Memo

Date: 12 June 2018

Ref: CT160213

Re: Response to PGL Review Memo Bragg Creek Flood Mitigation Project: Potential Pathways of Effect on Downstream Lands and Waters

SHEET TITLE
**1:2 YEAR FLOOD INUNDATION
EXTENTS AT TSUU T'INA RESERVE
AND REDWOOD MEADOWS**

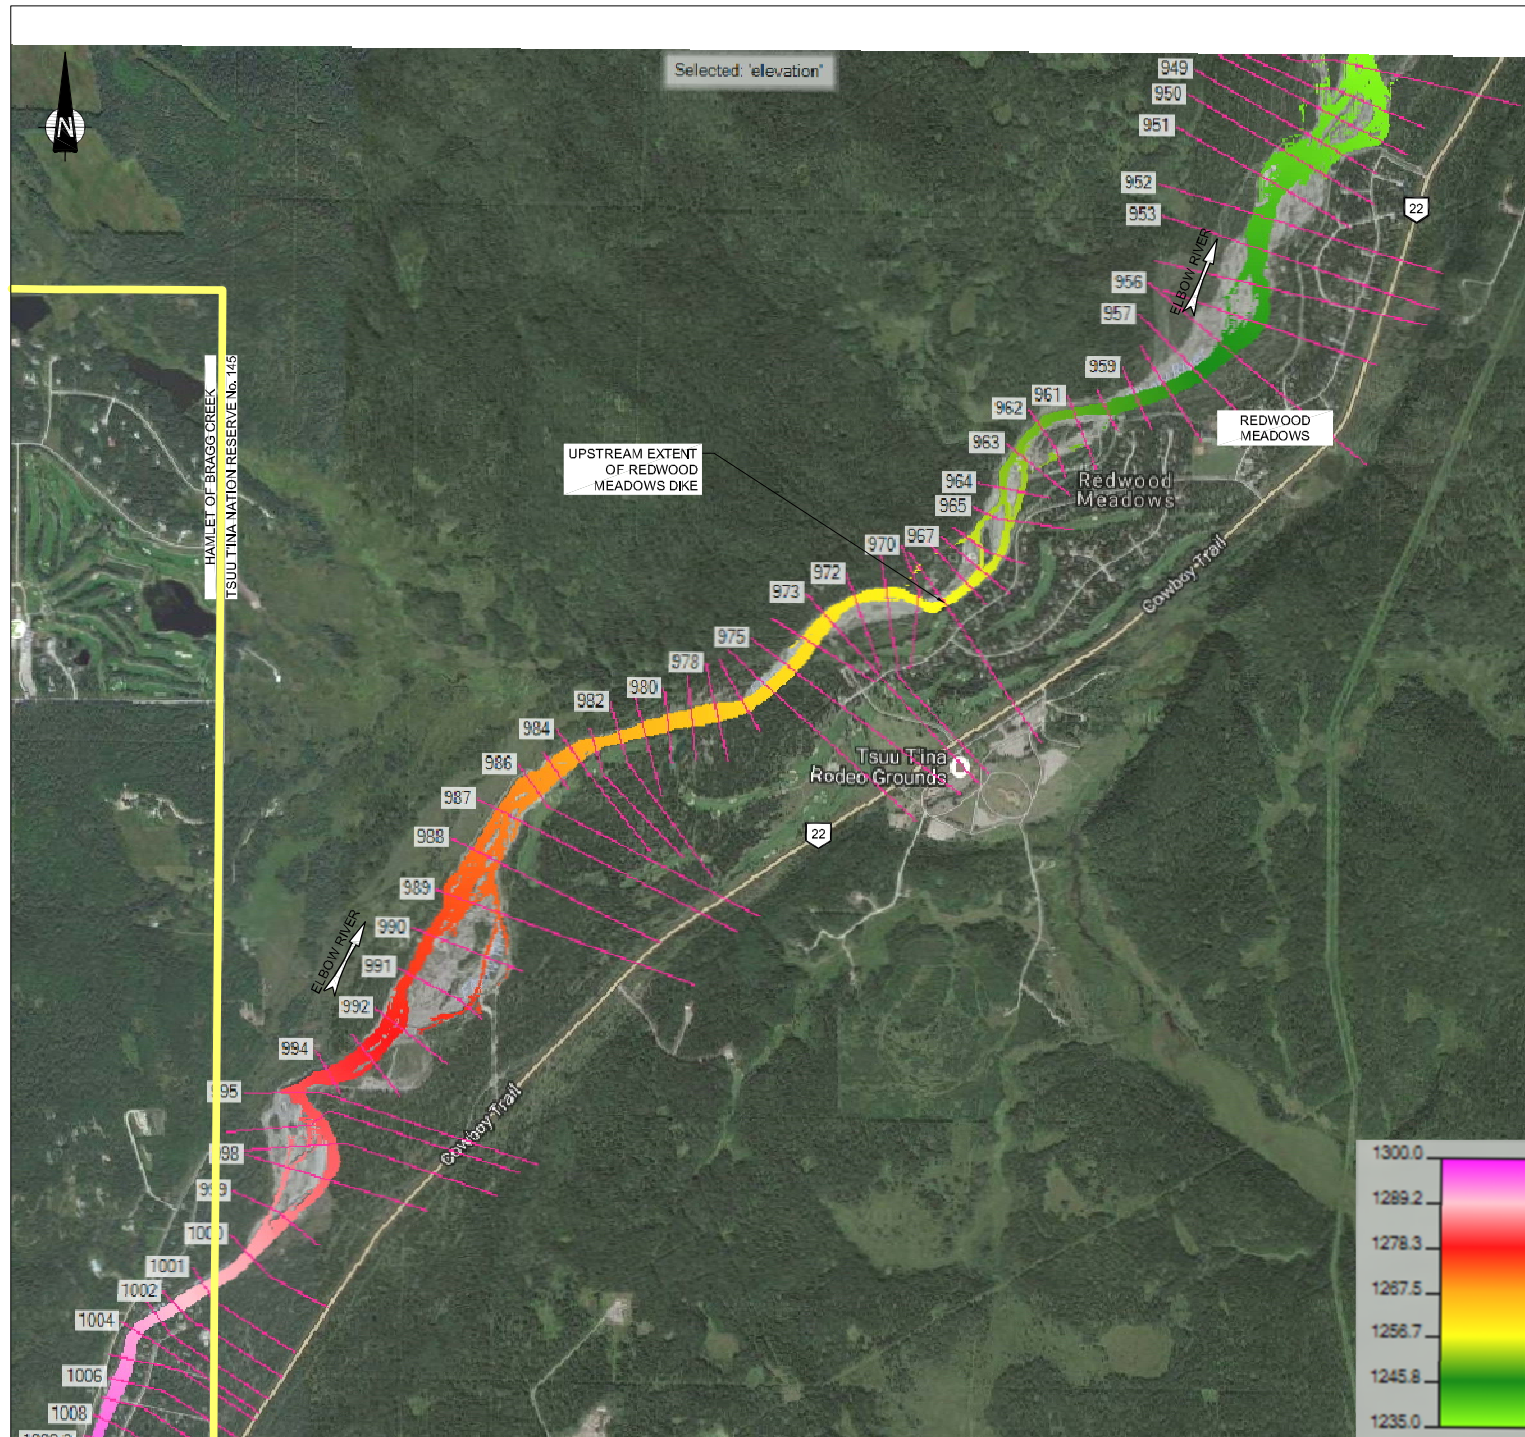
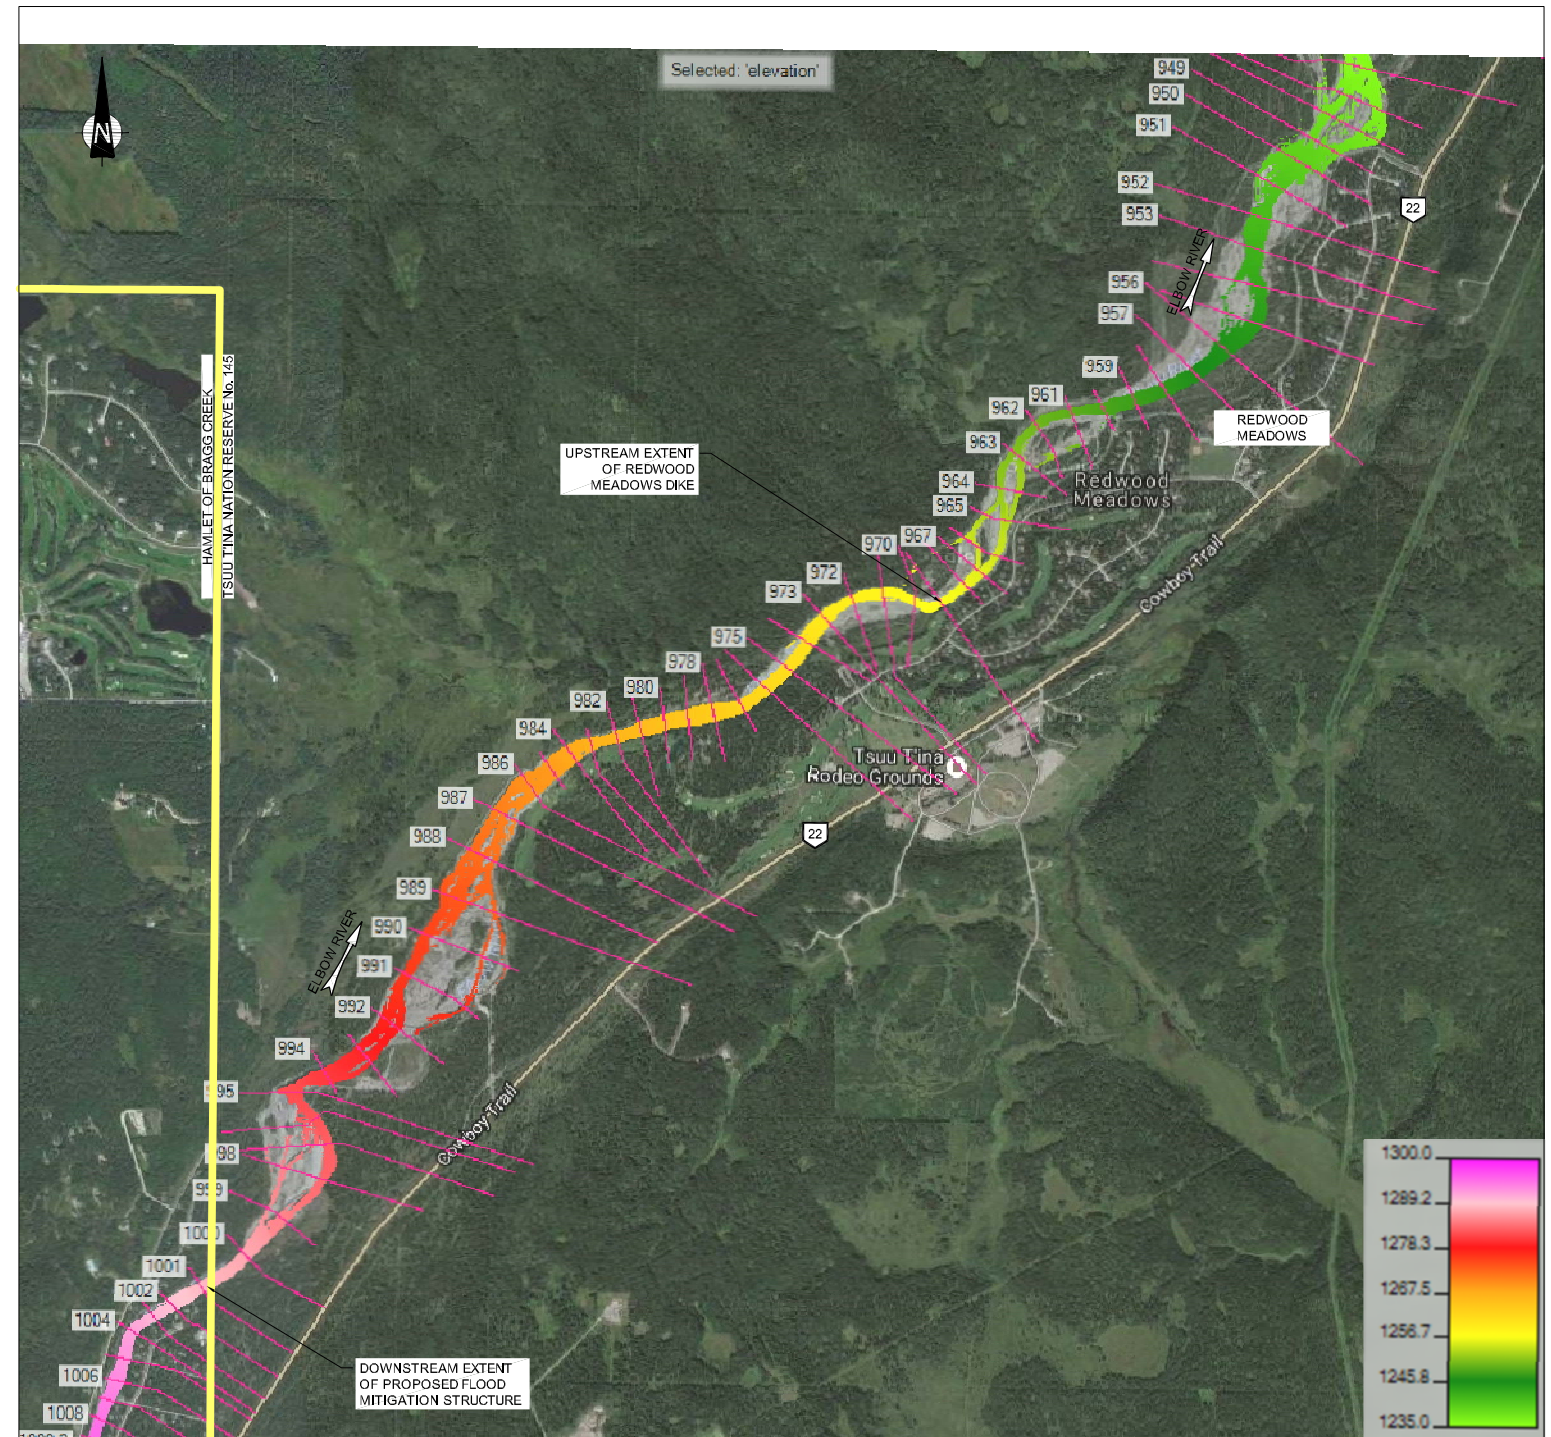
PGL Statement	Response by Wood
Water depth and speed will increase in the Elbow River in the reach of river bounded by Project infrastructure. The increase over base-conditions is predicted in the Application to be 0.31 m and 0.47m/s close to the boundary between Bragg Creek and IR145	The PGL statement is incorrect as the depth and velocity numbers quoted are with reference to the design flood of 990 m ³ /s. Our hydraulic model indicates that there are no increases in depth or velocity on the reserve land at the Hamlet boundary or beyond, for typical flood conditions .
Water depth and speed will attenuate beyond the downstream infrastructure. According to the Application, depth and volume will be indistinguishable from pre-project conditions (0.01m and 0.01m/s) at the downstream end of the community of Redwood Meadows	Similar response to above, the numbers referenced are with respect to the design flood of 990 m ³ /s. Our hydraulic model indicates that there are no differences in Redwood Meadows, for typical flood conditions .

Changes to river morphology (shape) may occur, but are expected to be minimal	On the basis of the above, no changes to river morphology would directly result from the Project, for typical flood conditions .
Increased water speed and volume may increase water turbidity (concentrations of suspended sediment), with corresponding potential effects on fish health and reproductive success	On the basis of the above, there will be no increase in water speed or volume. Hence, no increase in water turbidity (concentrations of suspended sediment), nor any potential effects on fish health and reproductive success

The concerns identified in PGL's section 1.5.1 are addressed below. This is for potential impacts under typical flood conditions (1:2 year Return Period flow of 57 m³/s). The attached **Figure 5.1**, which reflects the results of our hydraulic model, shows the flow patterns for the 2-year flood for both existing

conditions and flood protection conditions. As shown in the figure and in the discussion below, the proposed structure has no impact on the 2-year flood. Specific responses to PGL’s statements are contained below.

It should be noted that the proposed barrier surfaces are generally excavated into the existing river banks, or located above the 1:2 year flood water surface level, and for these reasons have no impact on water depth or speed upstream of the Tsuut’ina boundary in typical flood conditions.

SHEET TITLE
**1:20 YEAR FLOOD INUNDATION
EXTENTS AT TSUU T'INA RESERVE
AND REDWOOD MEADOWS**

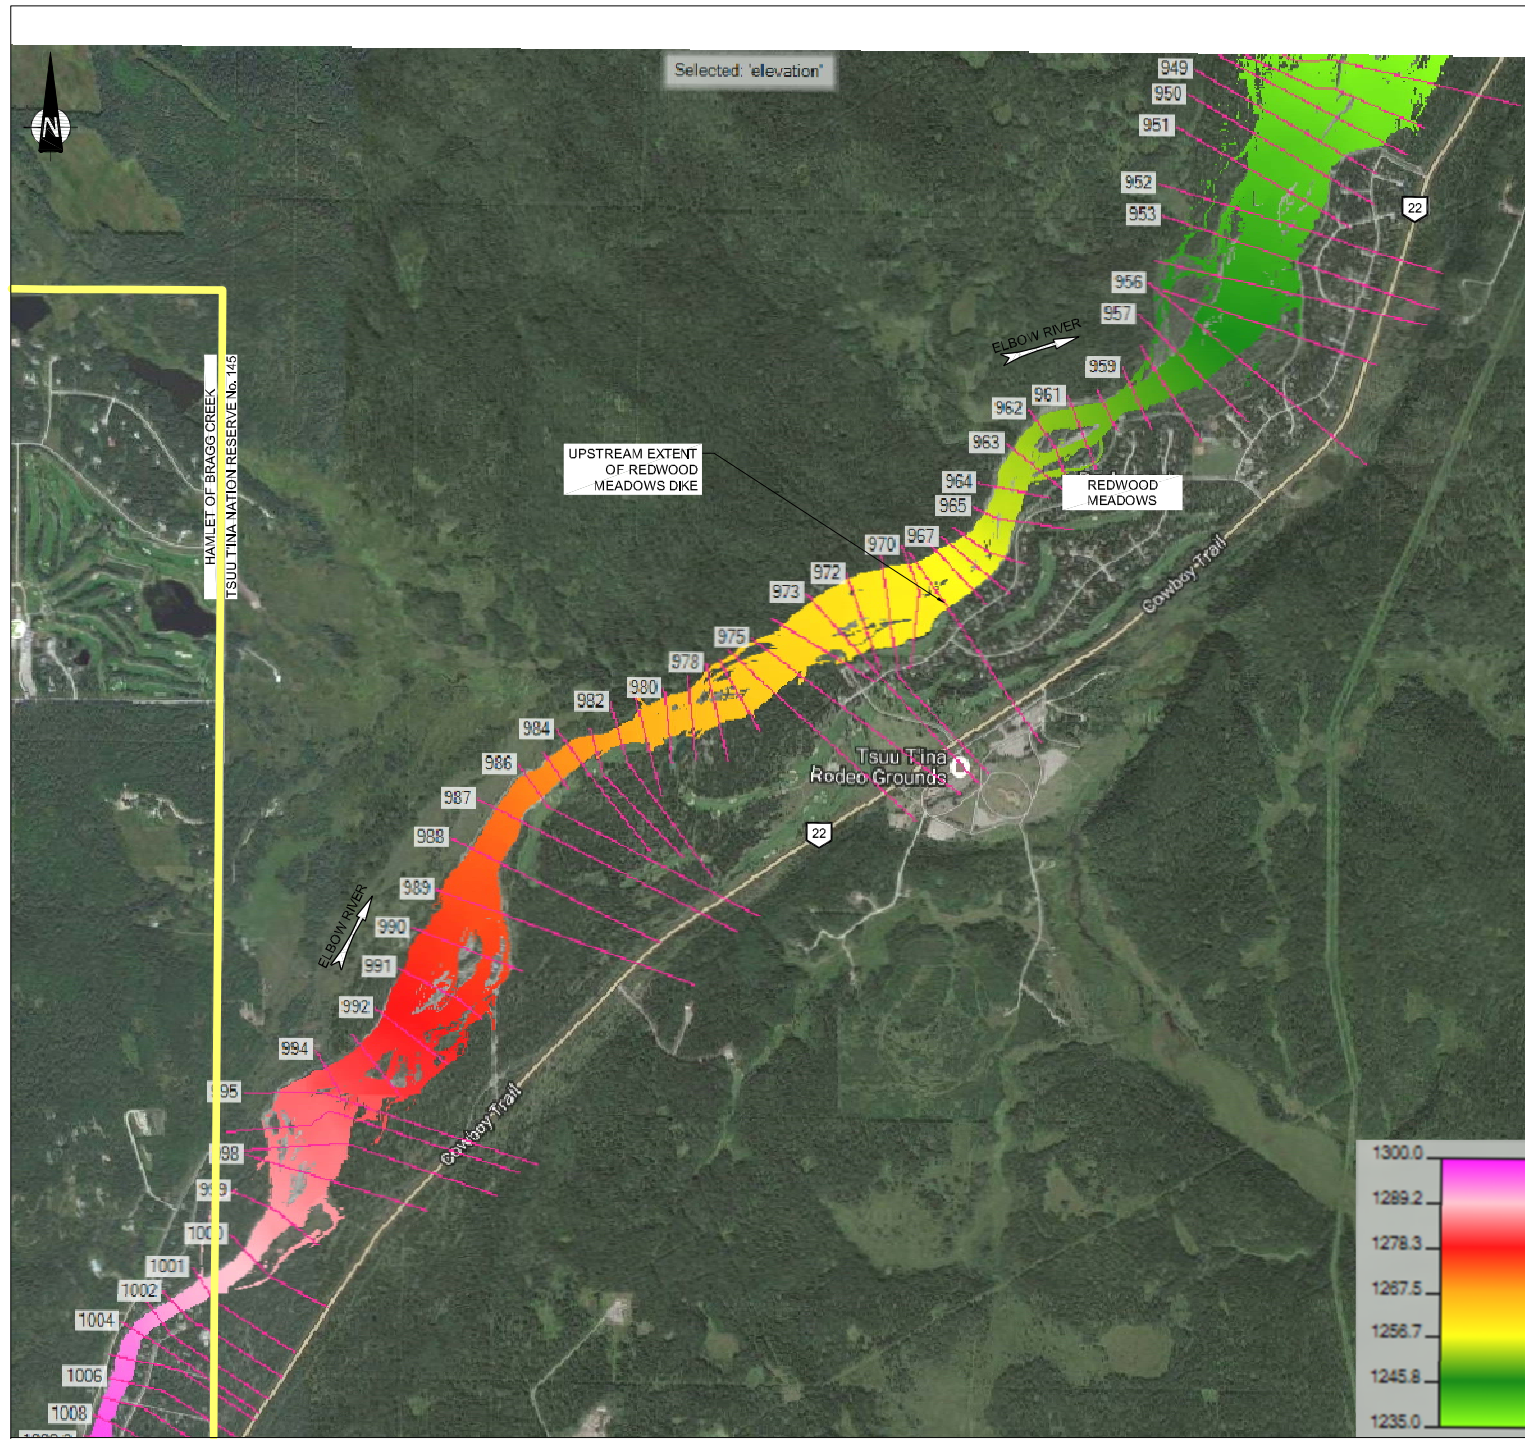
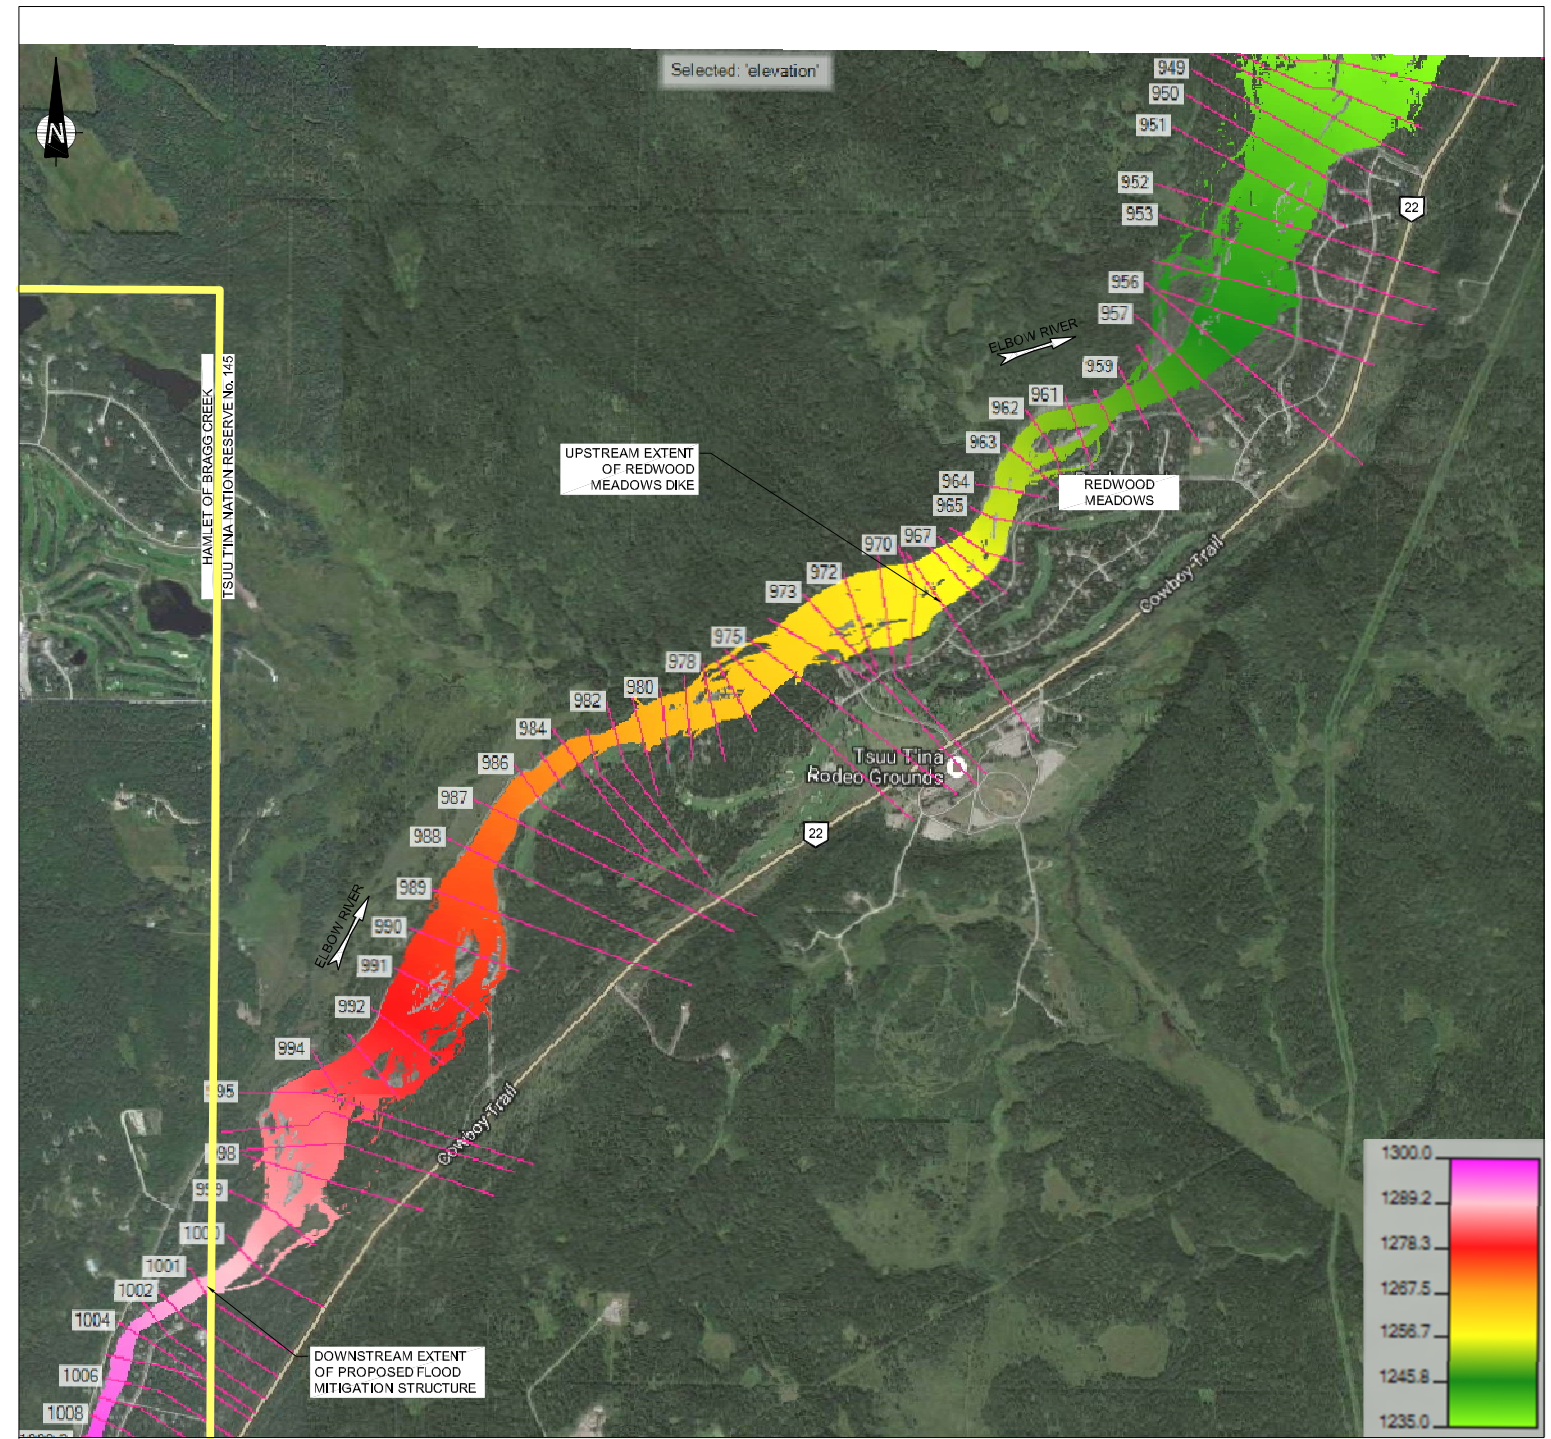
PGL Statement	Response by Wood
As above. water depth and speed will increase in the Elbow River in the reach of river bounded by the Project infrastructure;	Our hydraulic model indicates that, at the boundary of the reserve with the Hamlet, there is no significant difference in depth or velocities for even moderately large flood conditions.
Additional water energy has the potential to move more or larger material downstream towards the community of Redwood Meadows	Our hydraulic model indicates that there is no additional water energy, hence no additional potential to move more or larger material downstream for even moderately large flood conditions.
Gradual deepening of the Elbow River downstream of the project structure is likely. The speed at which this will occur depends on the frequency of high volume flooding	There will be no deepening based on the above statements and as previously noted, the stream profile is controlled by bedrock outcrops including one outcrop that is located 300 m downstream of the Hamlet boundary. Bedrock weathering and scour is a very slow process not influenced by infrequent flooding.

The concerns identified in PGL’s section 1.5.2 are addressed below. This is for potential impacts under moderately large flood conditions (1:20 year Return Period flow of 440 m³/s). The attached **Figure 6.1** shows the flow patterns for the 20-year flood for both existing conditions and flood protection conditions. As shown in the figure and in the discussion below, the proposed structure has no impact on the 20-year flood. Specific responses to PGL’s statements are contained below.
